Subject: Juniper Ridge Landfill Expansion Application, MEDEP #S-020700-WD-BI-N Follow-up to Department Staff's Responses to the March 4, 2016 Submittal on Staff's Review Comments as Presented in the Department's April 5, 2016 Letter

## EXHIBIT D

### **BGS AND NEWSME'S RESPONSE TO MEDEP'S APRIL 1, 2016 TECHNICAL MEMORANDA**

FIGURE U-14A-BEDROCK AMENDED DRAWDOWN INTERCONNECTIVITY IN BEDROCK AT COMPLETION OF SHORT-TERM PUMP TEST SITE ASSESSMENT REPORT JUNIPER RIDGE LANDFILL EXPANSION OLD TOWN, MAINE

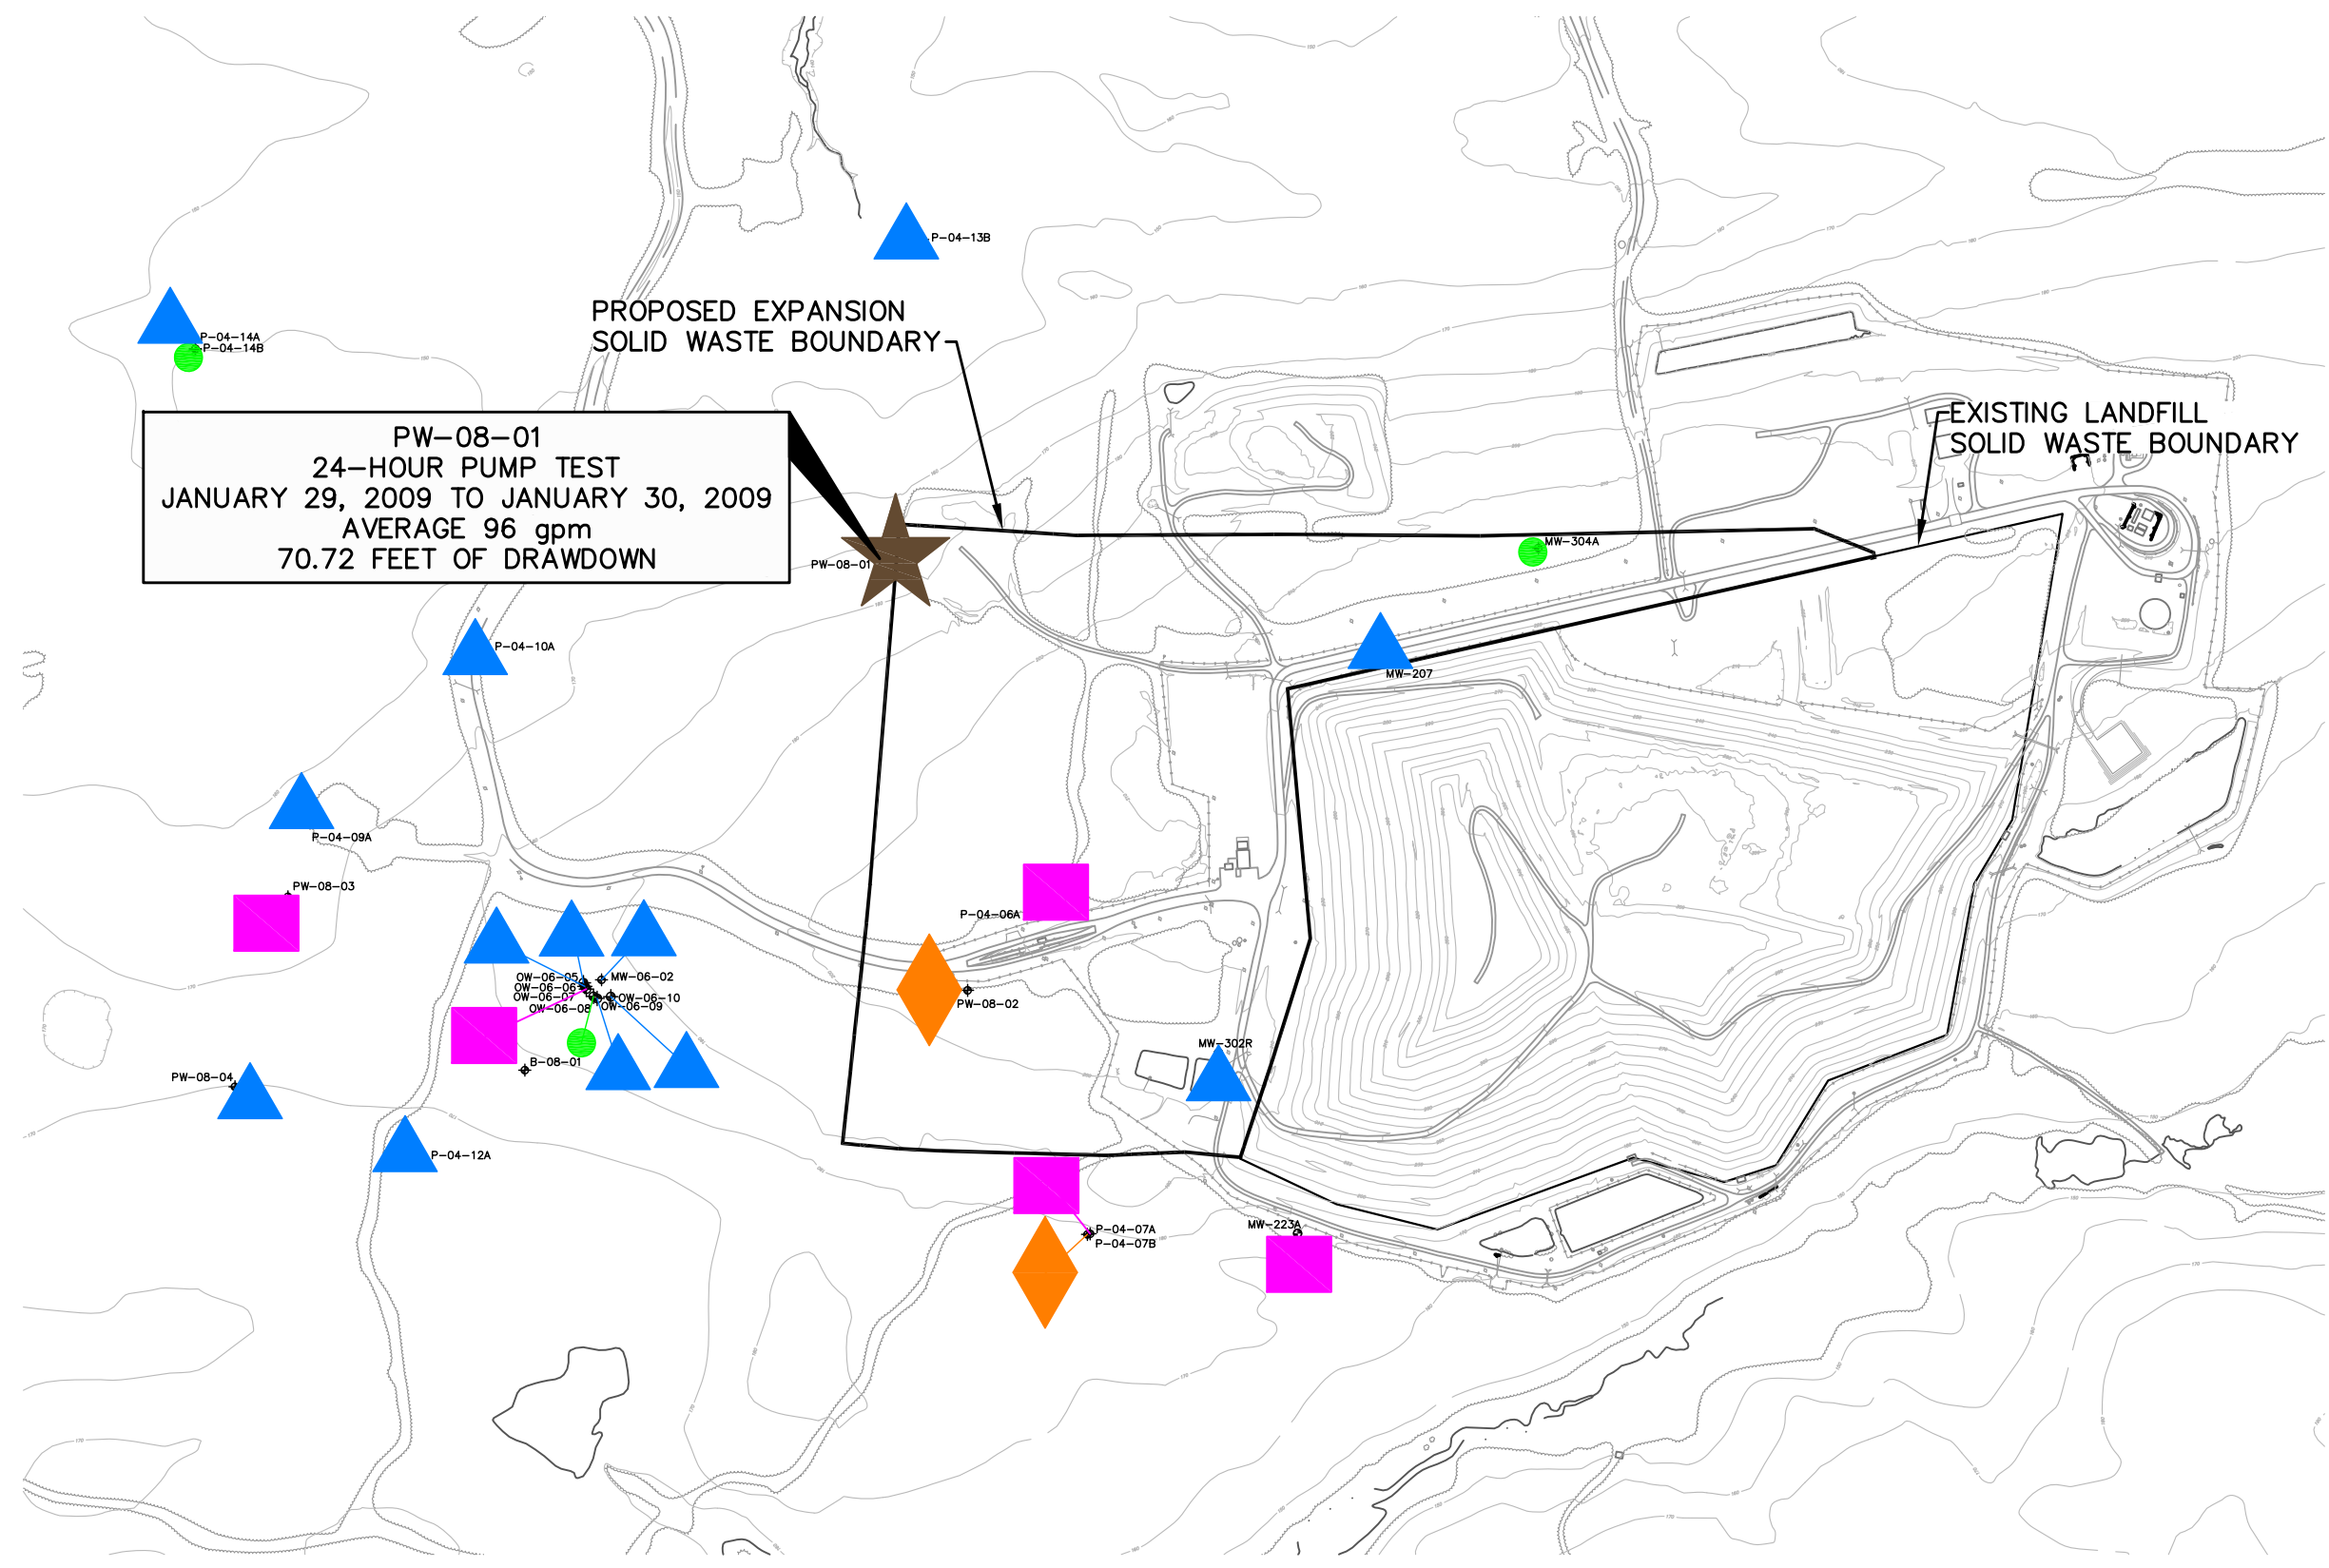
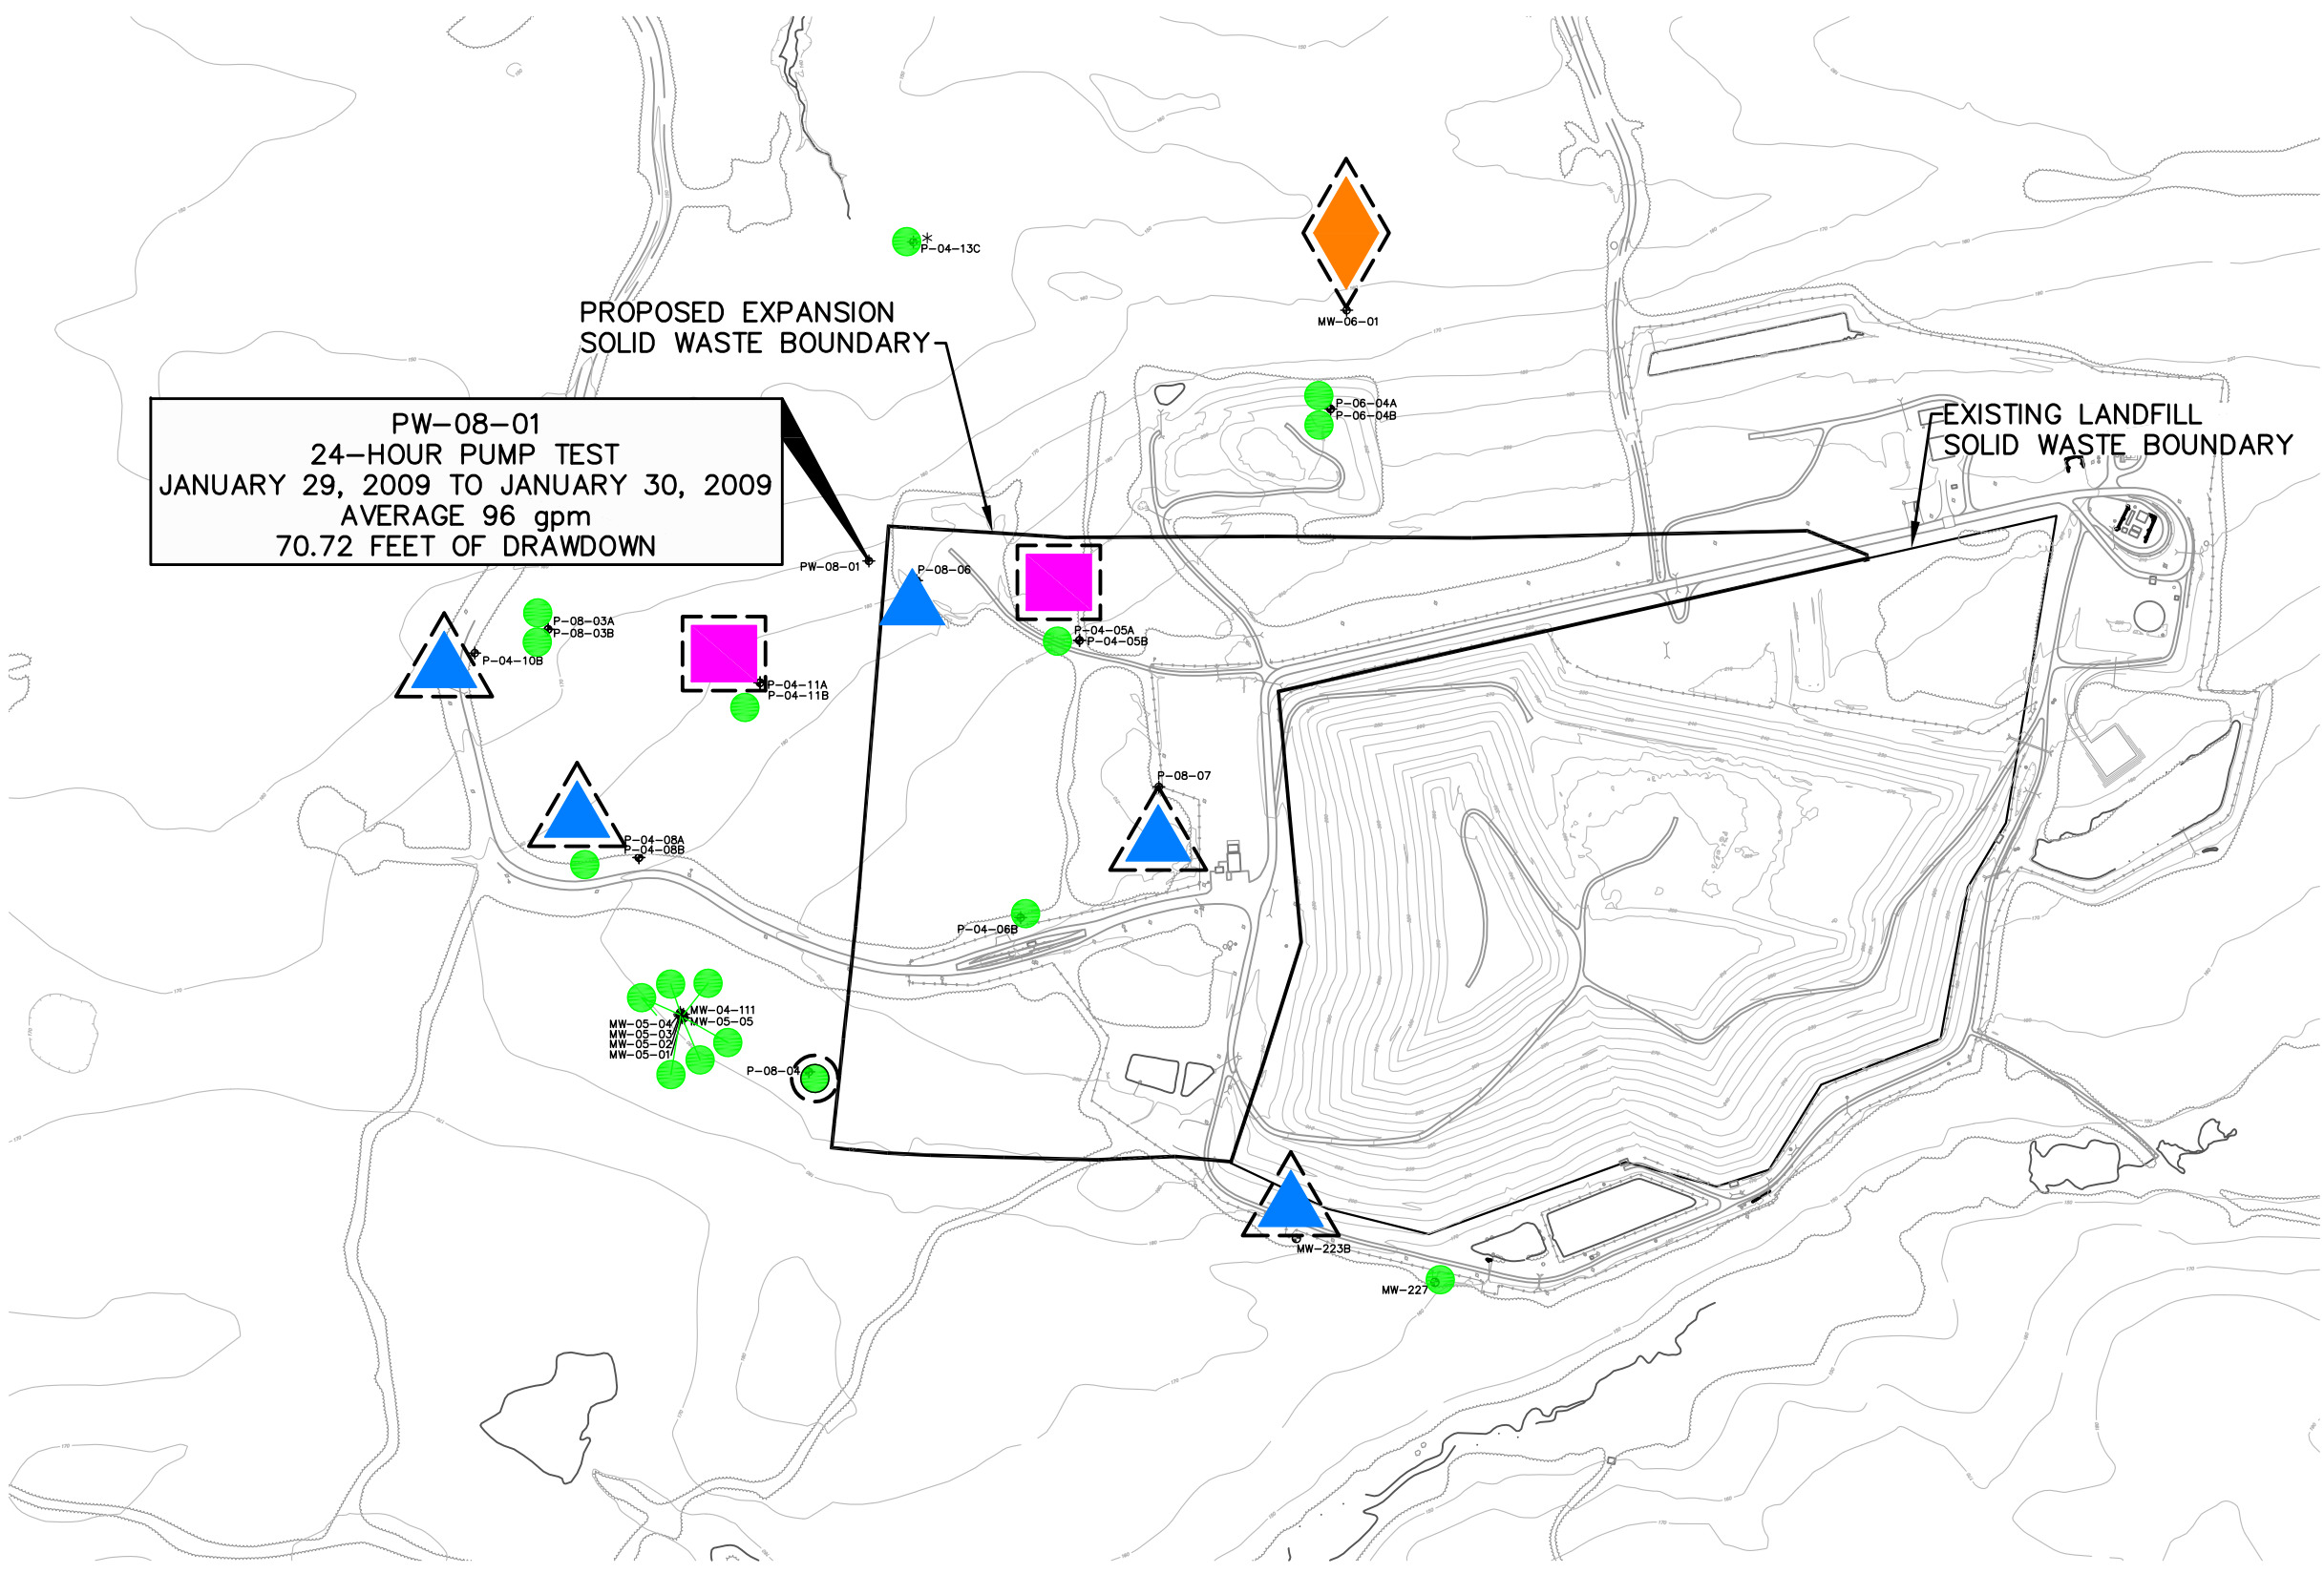
**MEDEP Follow-on Response: My original comment included a request for figures to illustrate the observed drawdowns in monitoring wells screened in the till. JRL's**

response did not include the requested figures. I continue to assert that a graphic depiction of locations where the till is hydraulically connected to the underlying bedrock is important and may assist in locating wells for long term monitoring and extraction wells in the unlikely event a significant leachate release were to occur.

**MEDEP – Follow-on Response:** JRL's response to my comments about Figures U-14 and U-15 do not adequately address my comments. Additional figures are needed to properly illustrate the data collected during each of the five pumping tests. To further enhance the results of the pumping test data, it is necessary to include all of the drawdown data obtained during each test. Again, I contend it is important to differentiate between bedrock and till wells. As an example, the figure (Figure U-14) illustrating the 26.5 hour pumping test performed on PW-08-04, uses graduated symbols to depict the range of observed drawdowns for only 20 of the 53 wells where water levels were observed. There are also apparent inaccuracies on the existing figures. The text on page 26 states six wells (5 bedrock and 1 till) experienced between 0.1 and 1.0 foot of drawdown although Figure U-14 only depicts three wells in this range. The figure (Figure U-15) depicting the drawdowns observed during the long-term pumping tests at PW-08-01 and PW-08-02 also requires revisions as only a fraction of the drawdown data is depicted on this figure. Although JRL collected drawdown data for 53 wells during the tests, Figure U-15 only depicts data for 21 wells.

To address these comments, I recommend JRL display all of the drawdown data for each pumping test on appropriately scaled figures. I also ask JRL to augment the drawdown data included in Appendix M with a table summarizing the total drawdown observed in all wells during each of the pumping tests. This table would include those wells instrumented with pressure traducers and those where manual water levels were made. I am certain JRL has previously compiled this data to complete the pumping tests analyses. I also request that JRL also provide the Department with an electronic copy of the spreadsheet.

Applicants' Response: Included in Attachment SME-D3 are ten figures augmenting Figures U-14 and U-15 included in Appendix U of Volume II of the Application. These figures show monitoring wells and piezometers where drawdowns were measured during the pumping tests. For each pumping test two figures, one showing the drawdown in the bedrock, and one showing the drawdown in the till, have been prepared. On the figures showing the drawdowns in the till the locations where the instrument screen is located within five feet of the bedrock surface are identified.

Applicants' Response: See previous response to the comment regarding Appendix U, Pg 25, 5.0 Pump Test Proof of Bedrock Interconnectivity. The augmented U-14 and U-15 figures are contained in Attachment SME-D3.
